X3T9.2/92-148 Rev 2

Date: July 21, 1992

Subject: **Active Negation Driver Requirements for SPI -- Rev 2**

Figure 6: Rise Time Test Circuit

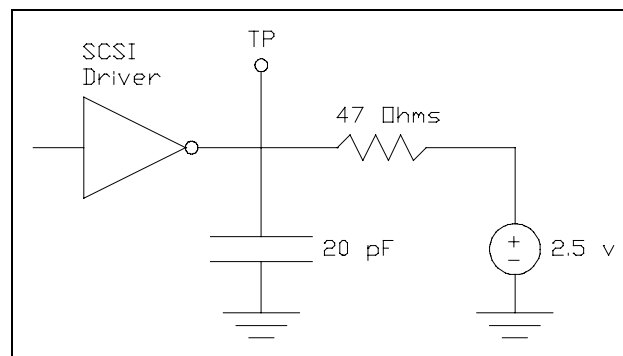
The recommended test circuit for measurement of rise time is shown in Figure 6.

[Use the correct figure; Florin has requested the cap be 15 pF]
